STERLING RECYCLING FACILITY

STREET IMPROVEMENT PLAN

STERLING RECYCLING FACILITY
COVER SHEET
SHEET 1 OF 10
JOB NO. 25188.14

STERLING RECYCLING FACILITY
HORIZONTAL CONTROL PLAN

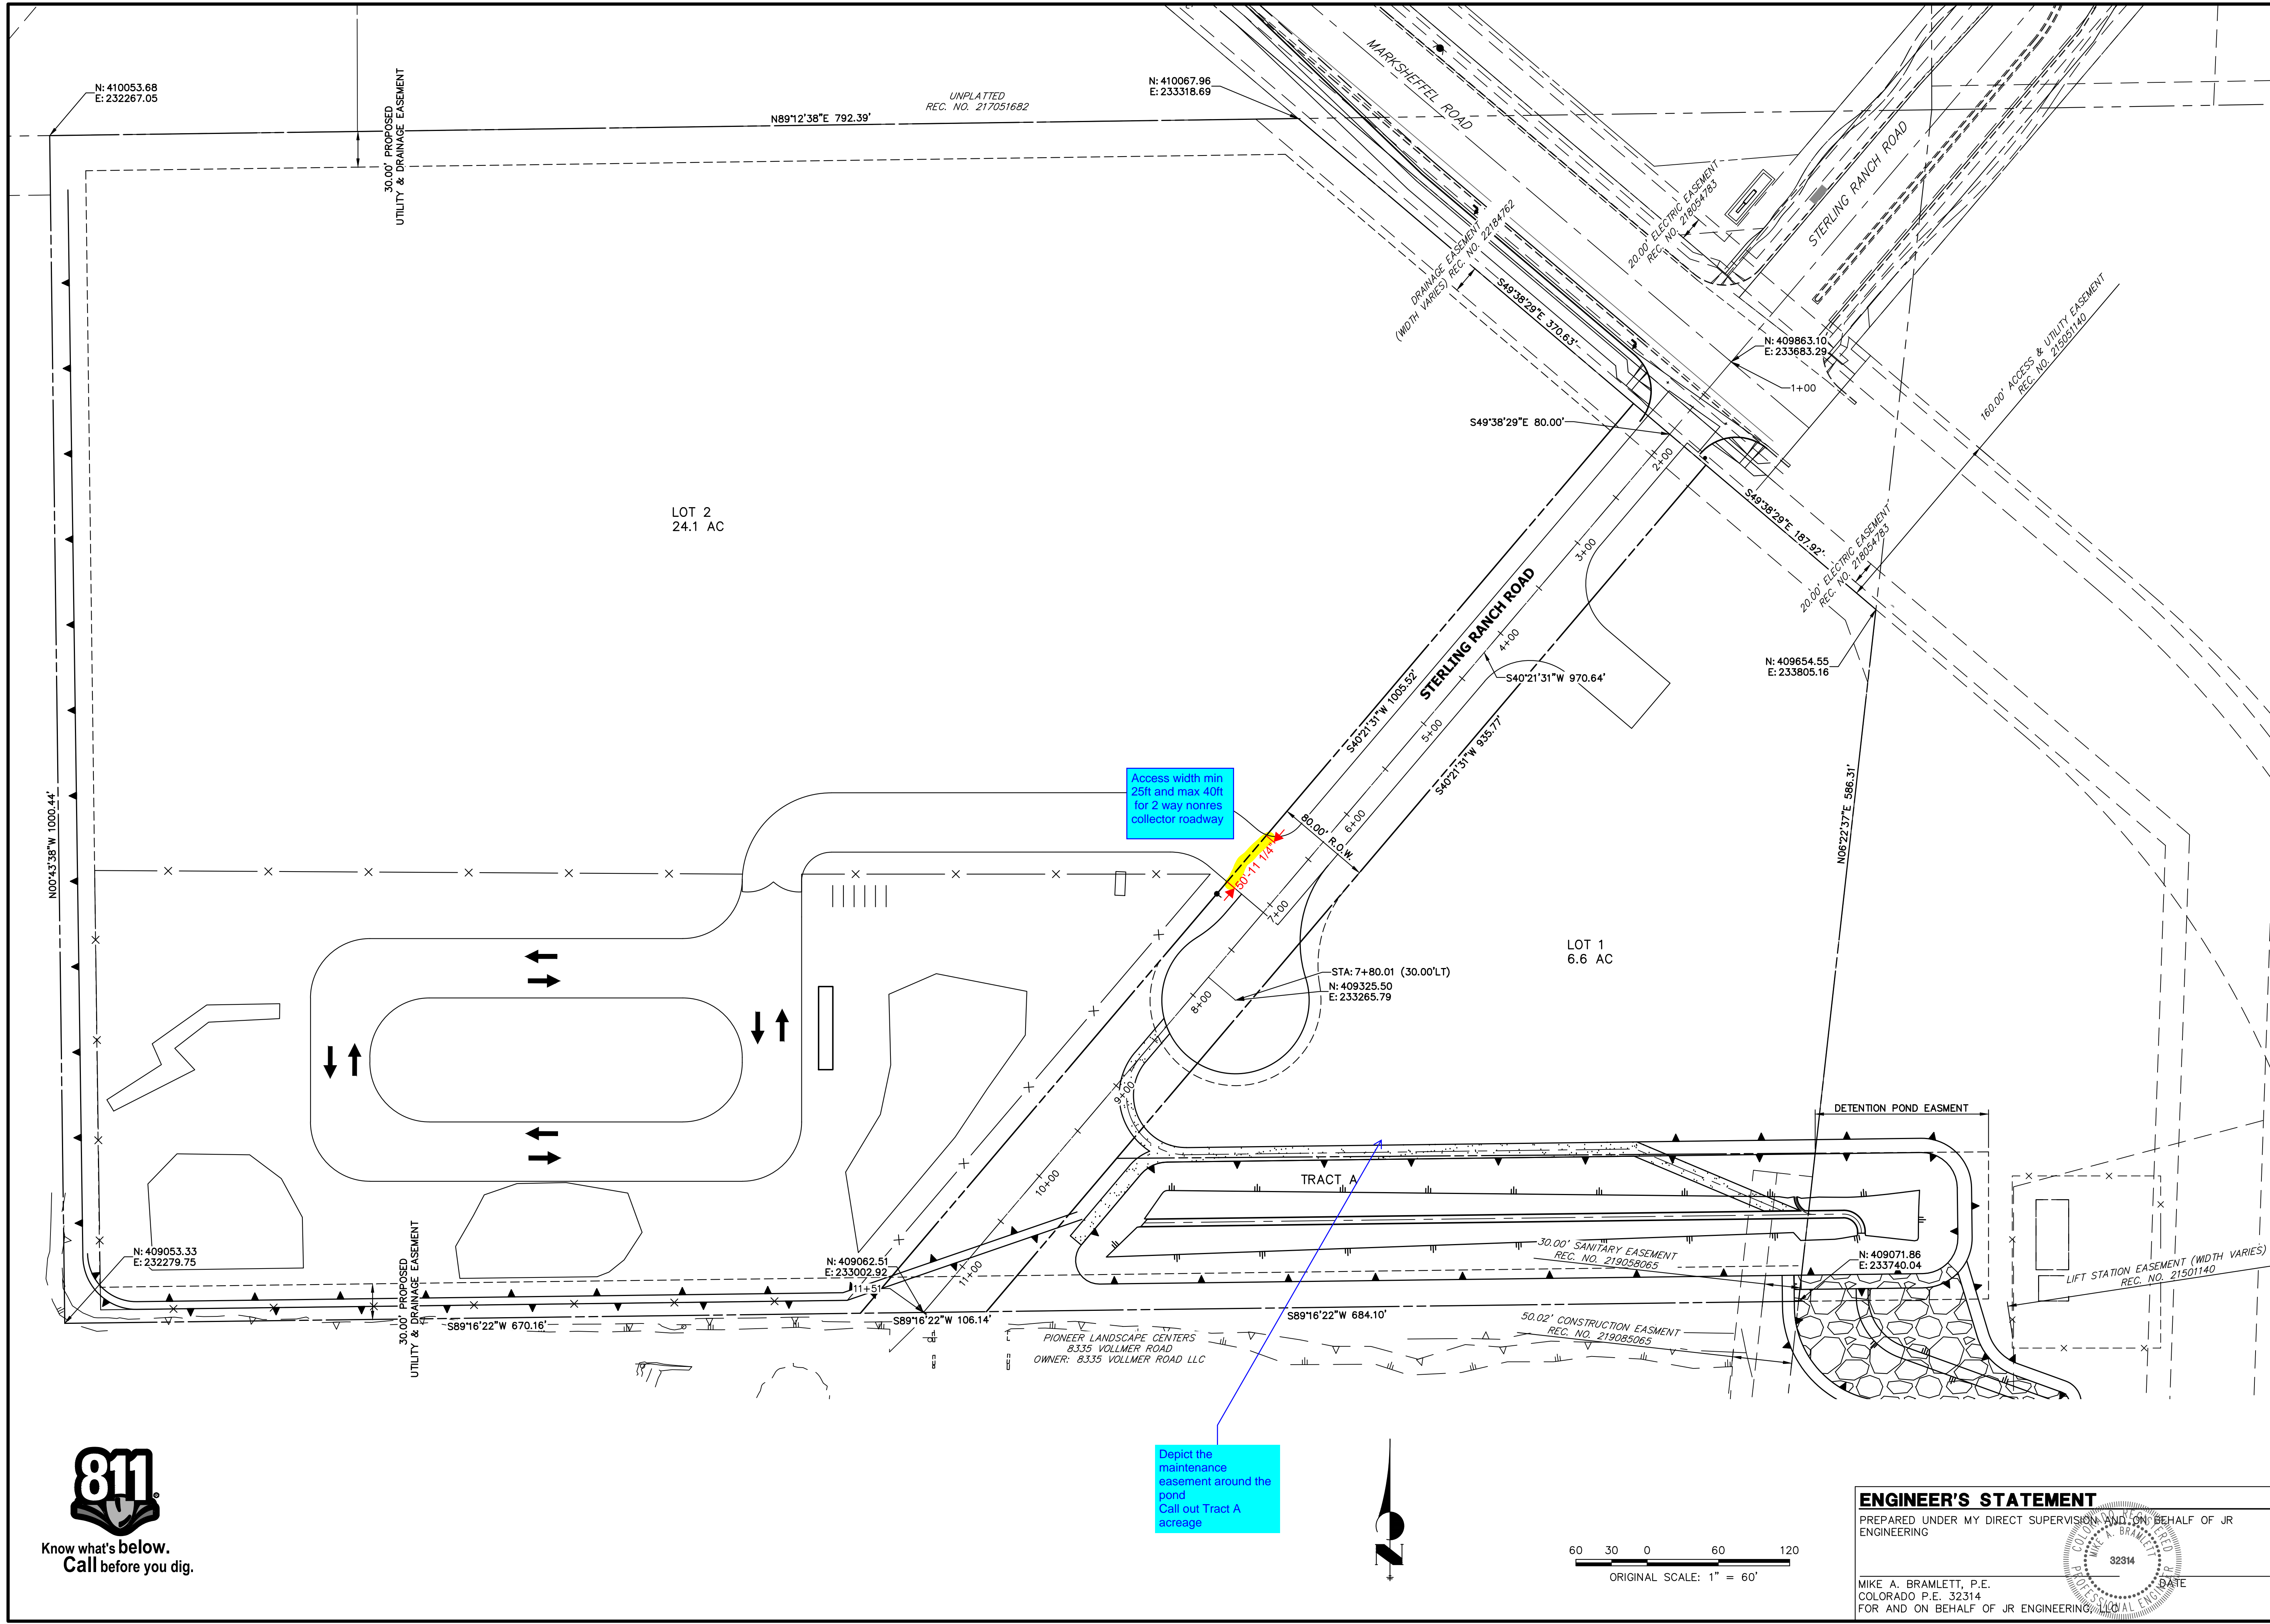
Access width min 25ft and max 40ft for 2 way nonres collector roadway

Depict the maintenance easement around the pond
Call out Tract A acreage

STERLING RECYCLING FACILITY
STREET PLAN & PROFILE
INTERIM

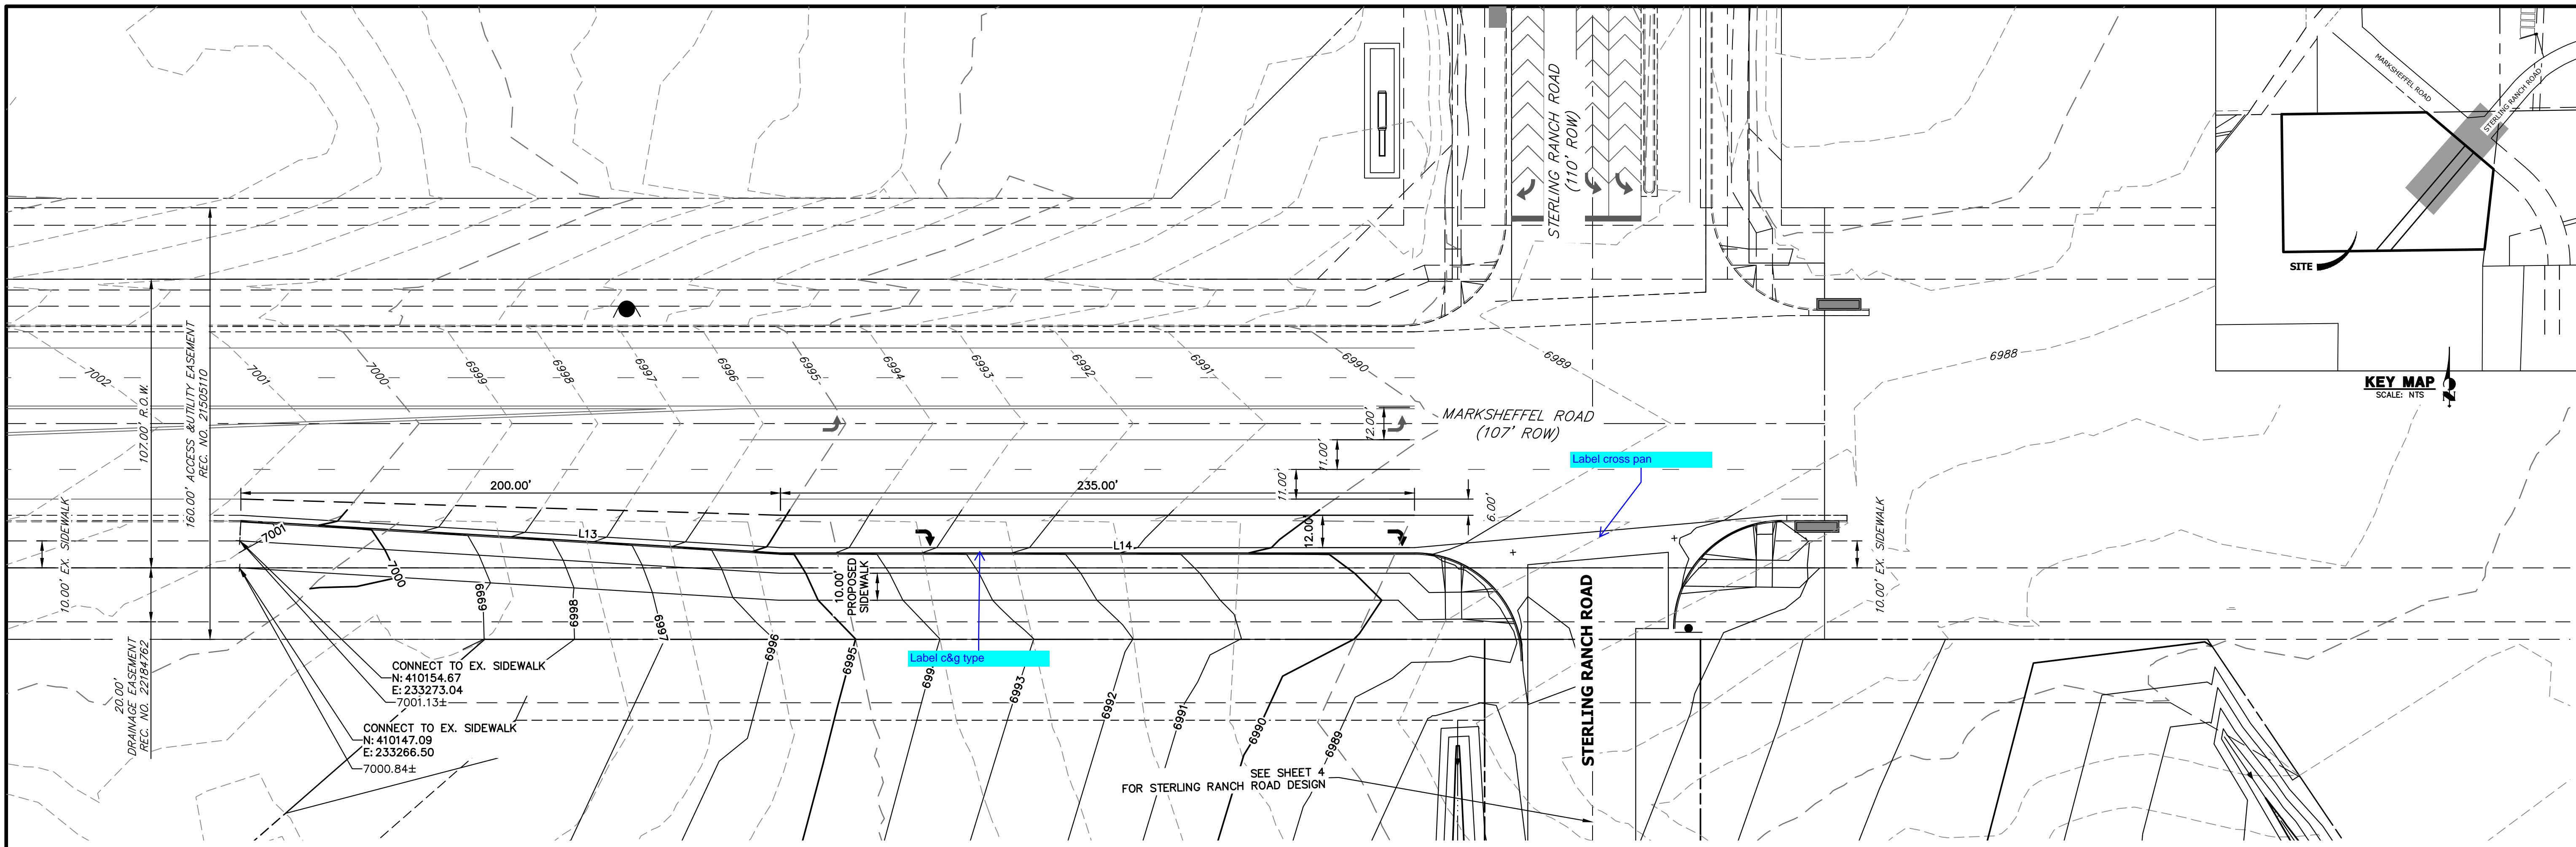
Label c&g type

Label cross pan

Provide cross section for Marksheffel,
indicating what's existing & what's new

**STERLING MARKSHEFFEL WEST FL PROF
STA 1+00.00 TO 2+00.68**

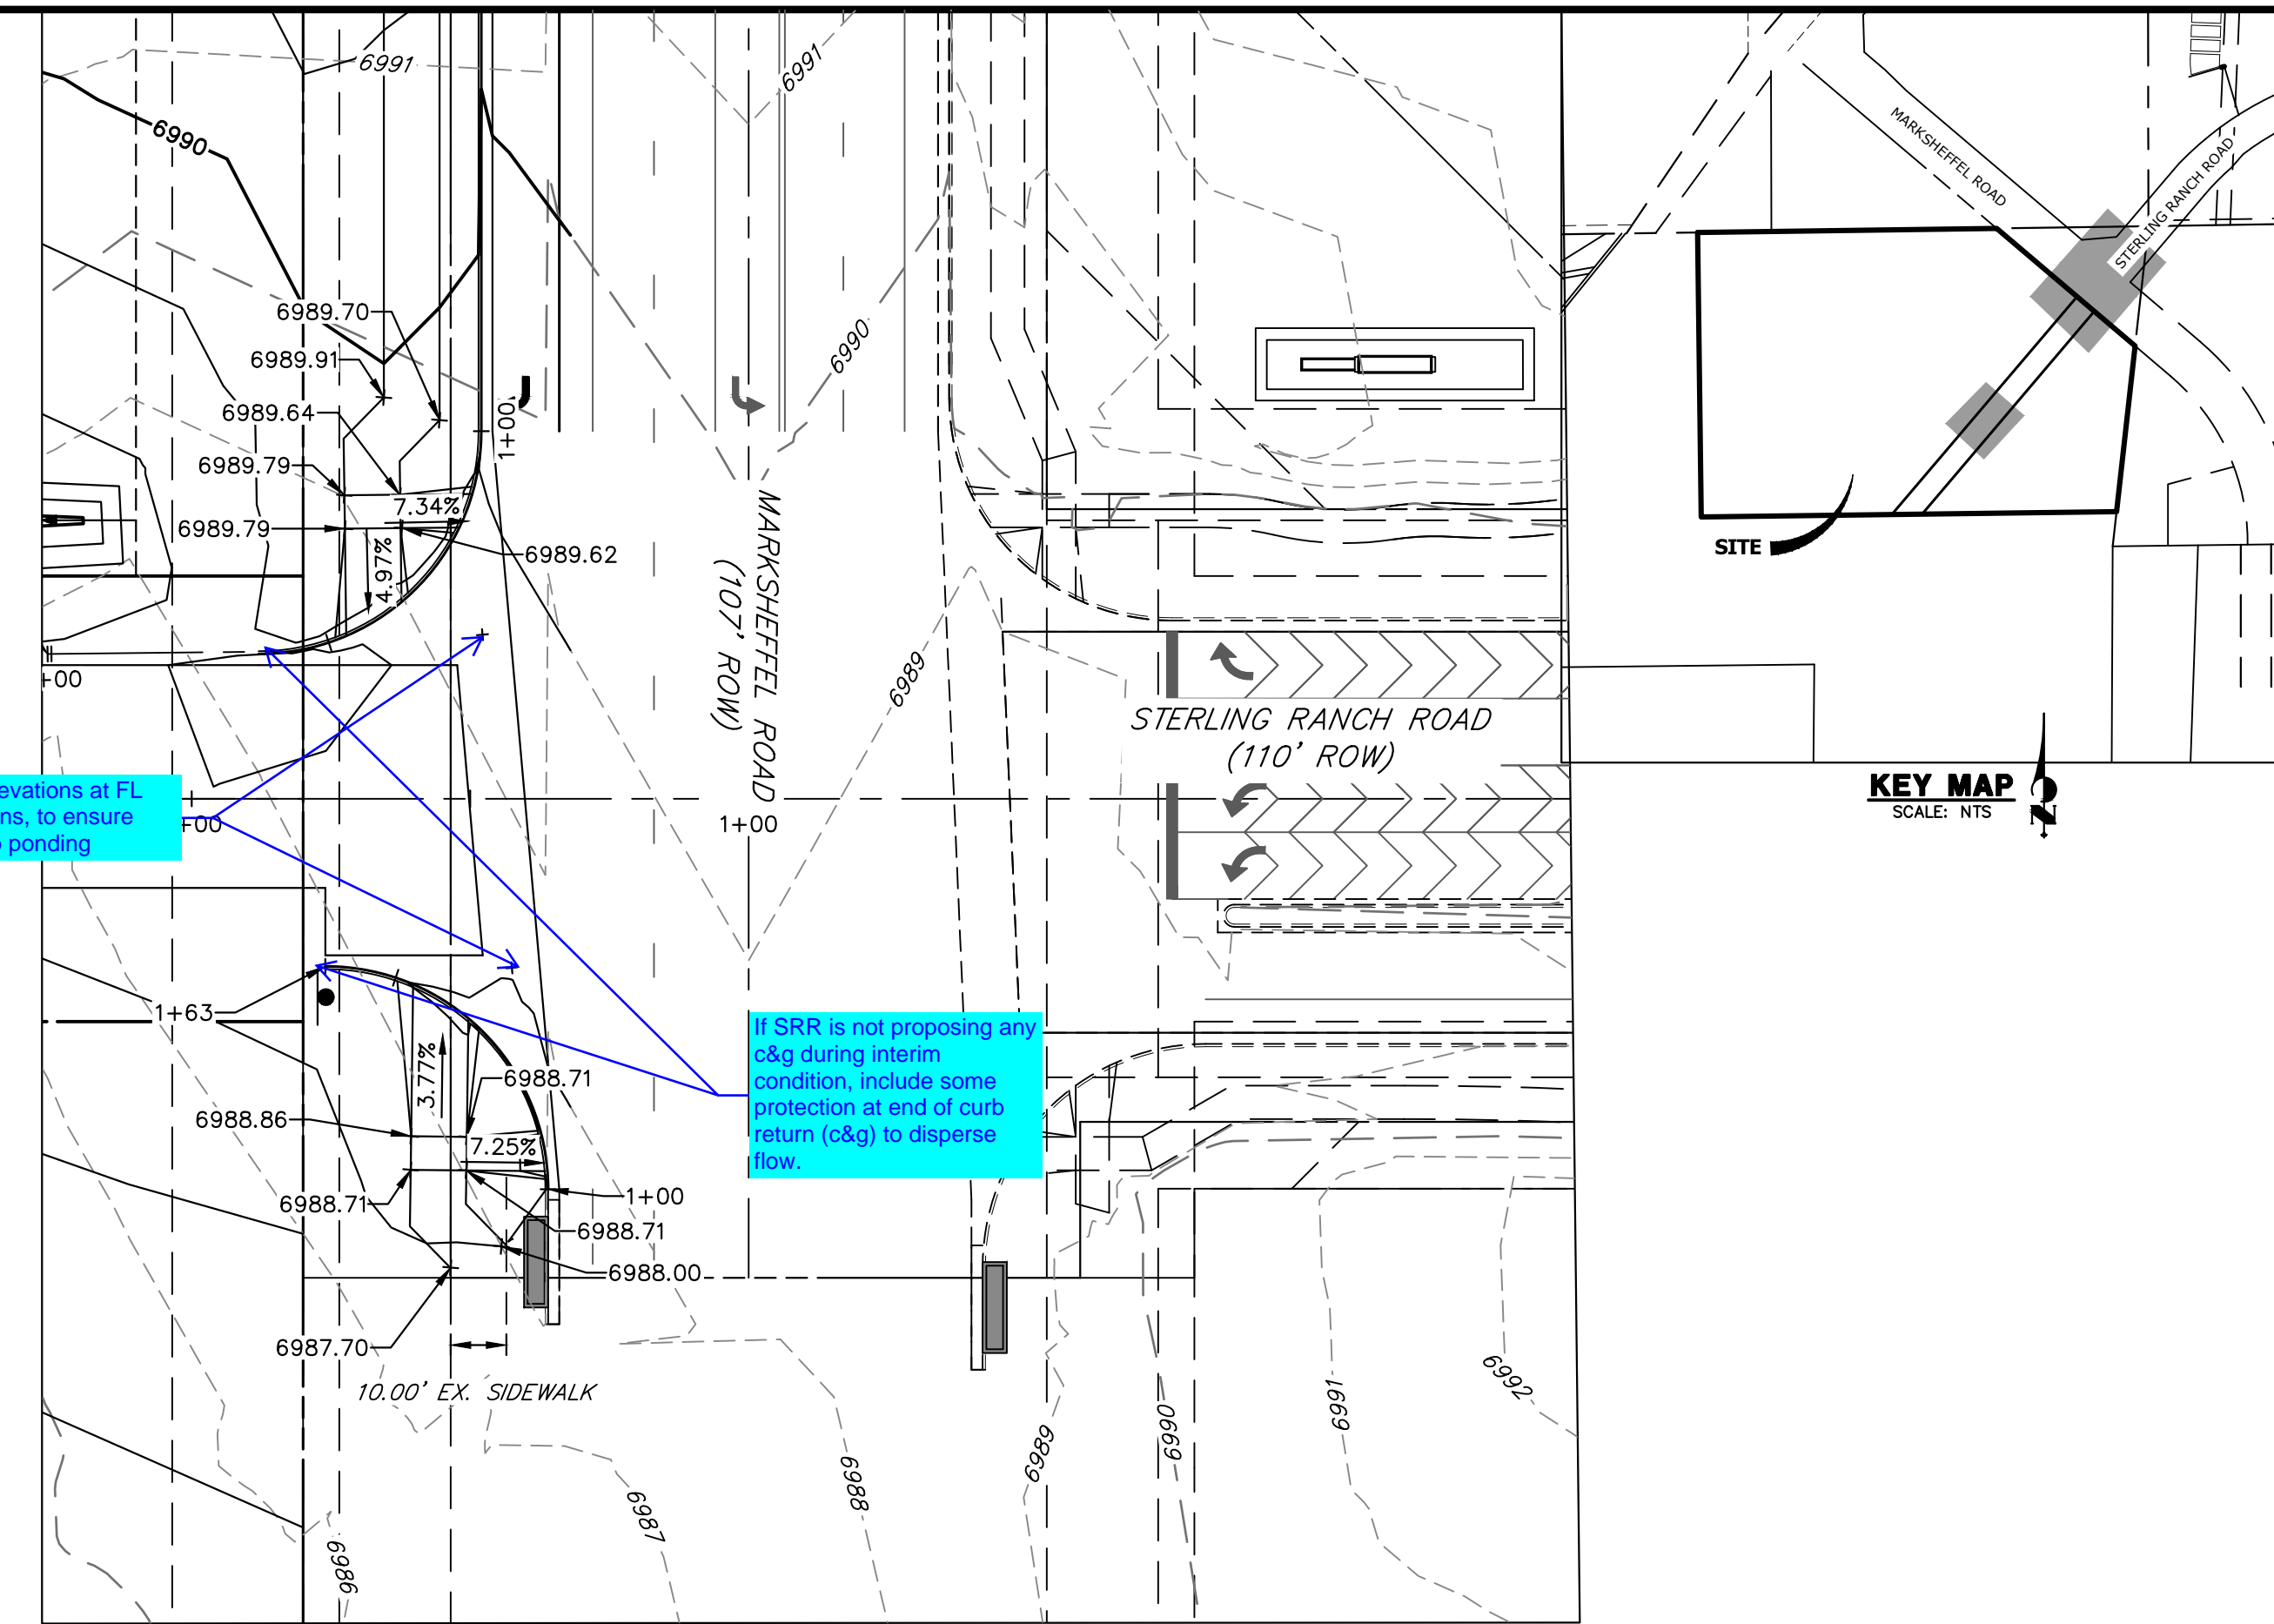
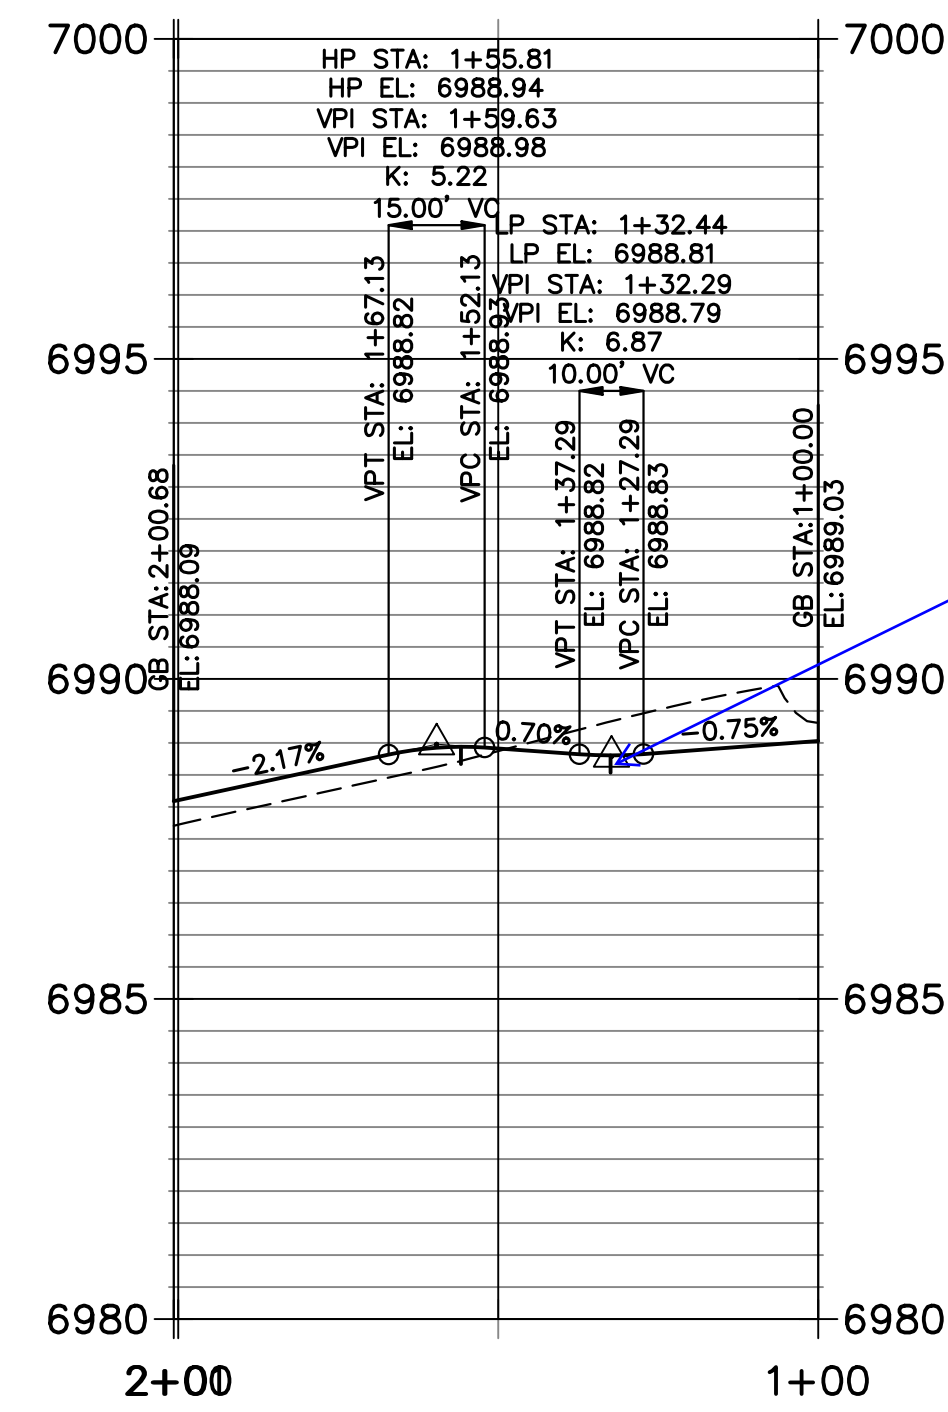
Provide elevations at FL intersections, to ensure there is no ponding
